# Technical Bulletin

## Timing Belt System replacement on VAG 1.8 20V engines (PowerGrip® Belt and Kits 5492XS)

<b>GATES REFERENCE :</b>	<b>PowerGrip and kit 5492XS</b>	
<b>MAKE :</b>	AUDI / VOLKSWAGEN	
<b>MODEL :</b>	A4, A6, Cabrio, Passat	
<b>MOTOR :</b>	1.8, 1.8 – 20v T	
<b>MOTOR CODE :</b>	AEB, ADR, AFY, AJL, ANB, ARG, ARK, APT, APU, AVV

Fig. 1 new system

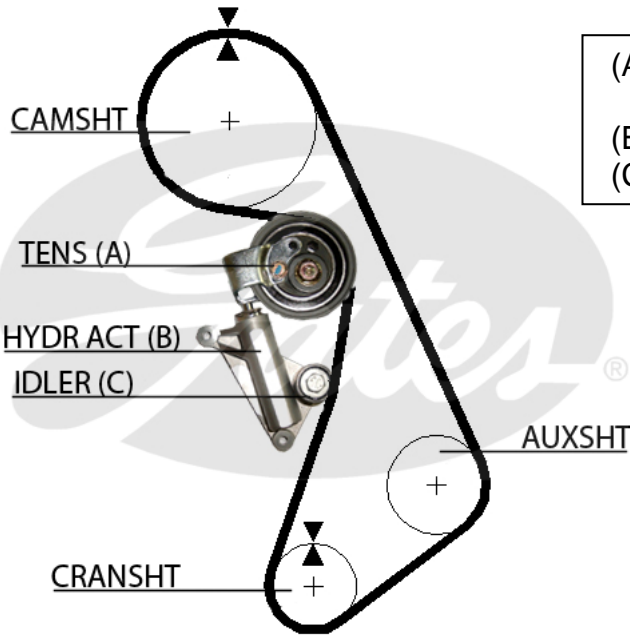
After durability problems it was decided to reengineer the synchronous system and to use an OE belt 058109119B/058109119C (5492XS - 153 teeth) together with a hydraulic actuator<sup>(2)</sup> 058109479B and a new tensioner pulley 058109243E (new system – Fig. 1).

**Note:** The old system is no longer available on OES level. It is strongly recommended to replace the entire system with the new system (Fig. 1) when the original timing belt needs replacement. Please make sure that parts of the old and new system are not being interchanged in order to avoid engine damage.
